UNITED STATES PATENT AND TRADEMARK OFFICE

APPLICATION NO.	FILING DATE	FIRST NAMED INVENTOR	ATTORNEY DOCKET NO.	CONFIRMATION NO.
09/883,818	06/18/2001	James F. McGuckin JR.	1243	2564

Office Action Summary

DETAILED ACTION

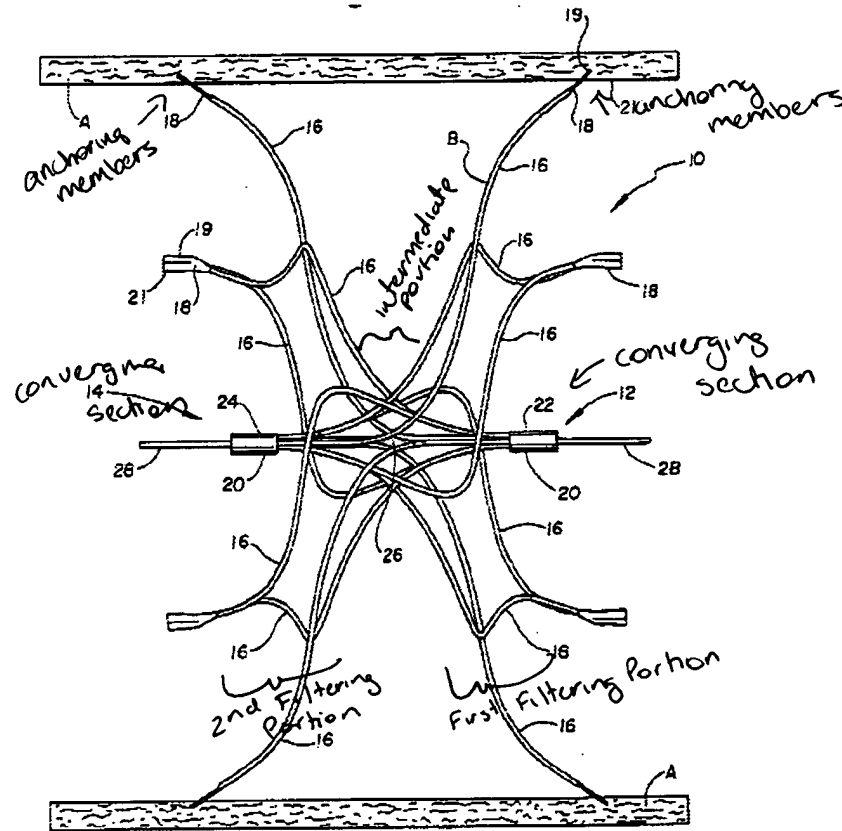
Regarding claim 1, Kotula discloses a vessel filter comprising a first filtering portion (64) and a first anchoring portion (66), a transverse dimension of the first filtering portion in an expanded configuration being less than a transverse dimension of the first anchoring portion in an expanded configuration (FIG. 5A), an end portion of the first anchoring portion spaced from the first filtering portion converging to a first converging section (15), and a second filtering portion (64) and a second anchoring portion (66), a transverse dimension of the second filtering portion being less than a transverse dimension of the second anchoring portion (FIG. 5A), an end portion of the second anchoring portion spaced from the first filtering portion converging to a second converging section (15), the first and second filtering portions being positioned closer to each other than the first and second anchoring portions and being configured to allow continuous blood flow therethrough while capturing clots (Column 11 lines 17-32), and the anchoring portions being formed on first and second opposite portions of the vessel filter (see attached FIG. 5A).

Regarding claim 7, Kotula discloses that the transverse dimensions of the first and second anchoring portions are substantially equal and the transverse dimensions of the first and second filtering portions are substantially equal (FIG. 5A).

Regarding claims 8 and 28, Kotula discloses that each of the filtering portions progressively increases in diameter to its respective anchoring portion, the anchoring portions being on opposing sides of the filter with the filtering portion therebetween (FIG. 5A).

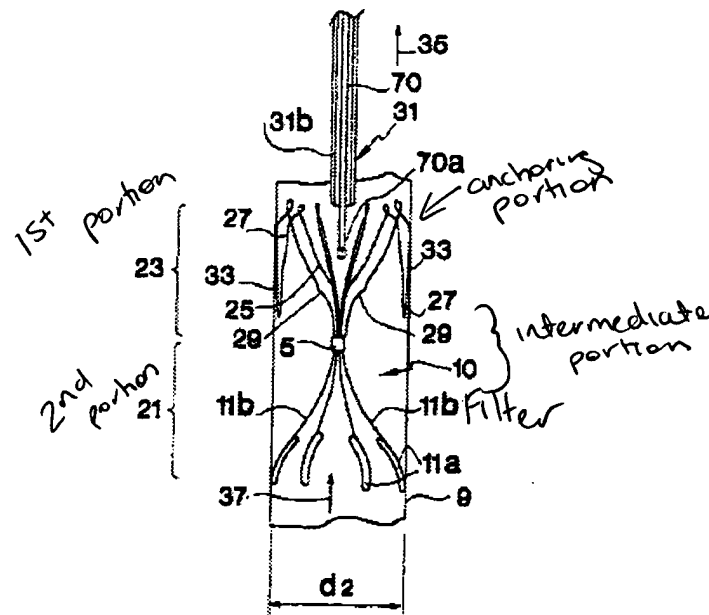
Regarding claim 9, Chevillon discloses a surgical apparatus comprising a vessel filter having a first portion, a second portion and an intermediate portion between the first and second portions (FIG. 5), the first portion increasing in diameter from the intermediate portion towards a first end, and the second portion increasing in diameter from the intermediate portion towards a second end, a region closer to the intermediate portion forming a filter portion and a region further from the intermediate portion forming an anchoring portion to retain the filter within the vessel, and the filter being configured to allow continuous blood flow therethrough while capturing clots, the anchoring

portion dimensioned to contact the vessel wall and are spaced radially from a central axis of the apparatus, wherein elements of the anchoring portion extend radially distally in a first direction and bend back to extend proximally in a second direction (see attached FIG. 5).

Claim 1

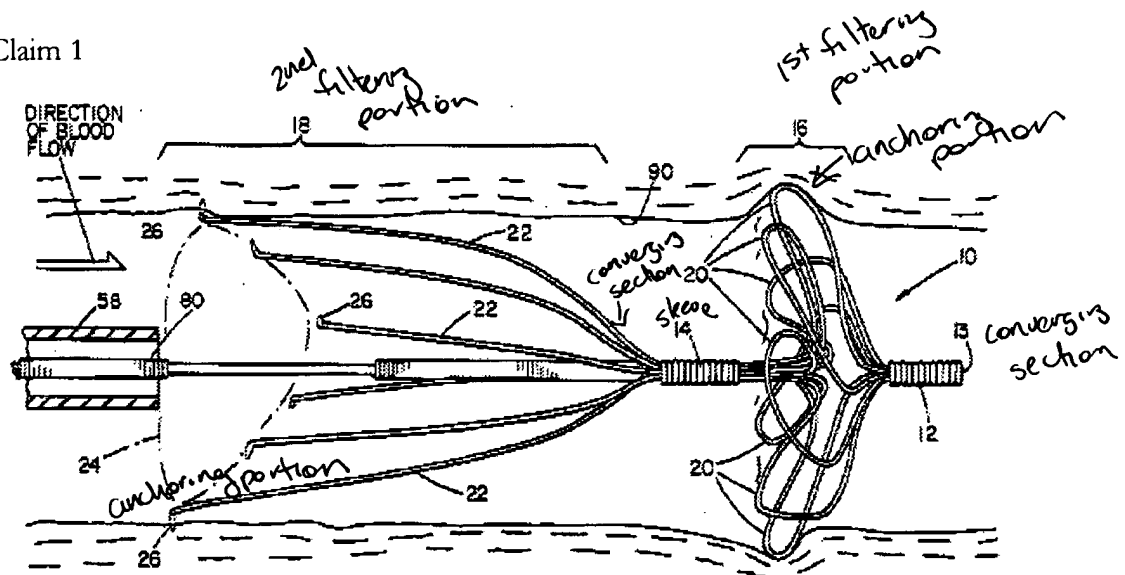
Regarding claim 1, Simon discloses a vessel filter comprising a first filtering portion and a first anchoring portion, a transverse dimension of the first filtering portion in an expanded configuration being less than a transverse dimension of the first anchoring portion in an expanded configuration, an end portion of the first anchoring portion spaced from the first filtering portion

converging to a first converging section, and a second filtering portion and a second anchoring portion, a transverse dimension of the second filtering portion being less than a transverse dimension of the second anchoring portion, an end portion of the second anchoring portion spaced from the first filtering portion converging to a second converging section, the first and second filtering portions being positioned closer to each other than the first and second anchoring portions and being configured to allow continuous blood flow therethrough while capturing clots, and the anchoring portions being formed on first and second opposite portions of the vessel filter (see attached Figure 1).

Claim 9

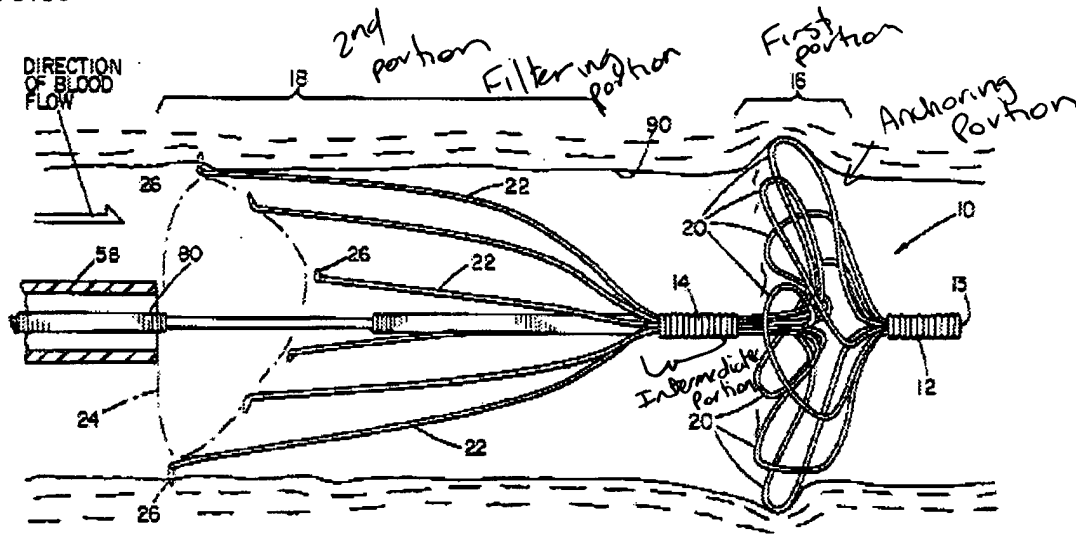
Regarding claim 9, Simon discloses a surgical apparatus comprising a vessel filter having a first portion, a second portion and an intermediate portion between the first and second portions, the first portion increasing in diameter from the intermediate portion towards a first end, and the second portion increasing in diameter from the intermediate portion towards a second end, a region closer to the intermediate portion forming a filter portion and a region further from the intermediate portion forming an anchoring portion to retain the filter within the vessel, and the filter being configured to allow continuous blood flow therethrough while capturing clots, the anchoring portion dimensioned to contact the vessel wall and are spaced radially from a central axis of the apparatus, wherein elements of the anchoring portion extend radially distally in a first direction and bend back to extend proximally in a second direction (see attached FIG. 1).
